Final Drainage Report
for
The Enclaves
at
Stonebridge Filing 4
at
Meridian Ranch

EL PASO COUNTY, COLORADO

July 2018

PCD Project No. PUDSP-18-003

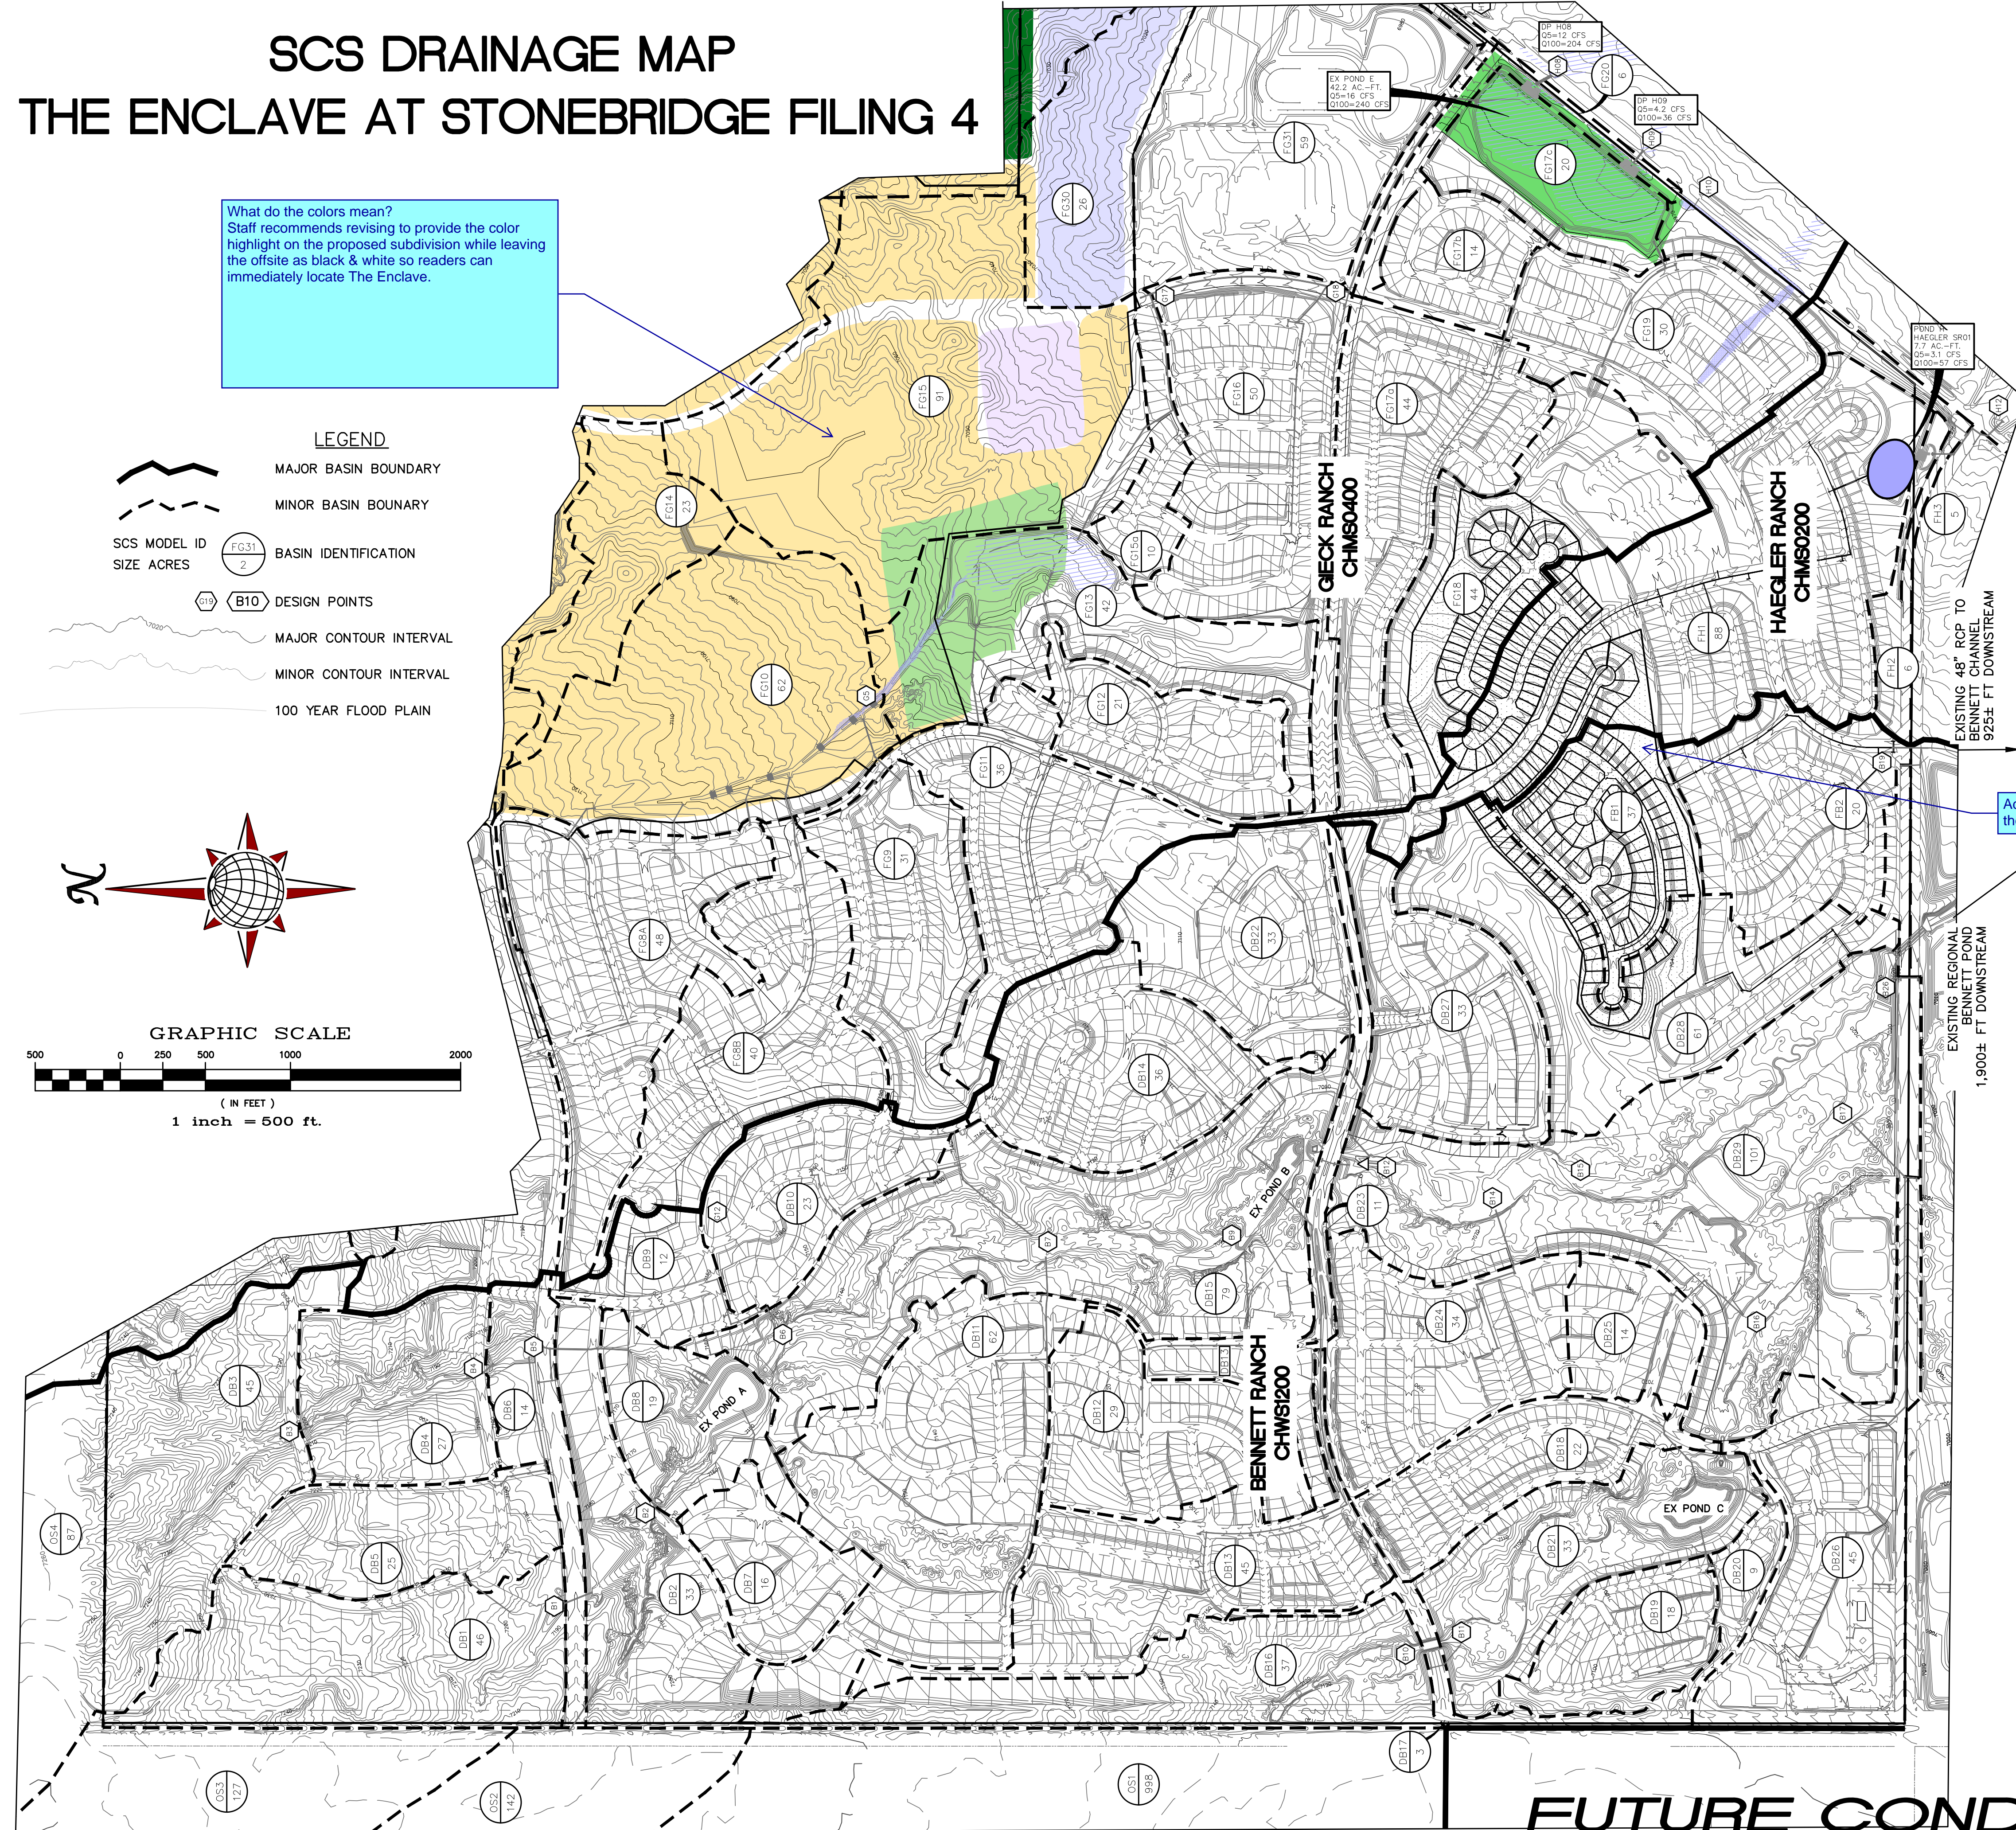
What do the colors mean?
Staff recommends revising to provide the color highlight on the proposed subdivision while leaving the offsite as black & white so readers can immediately locate The Enclave.

Add the hatching in the legend
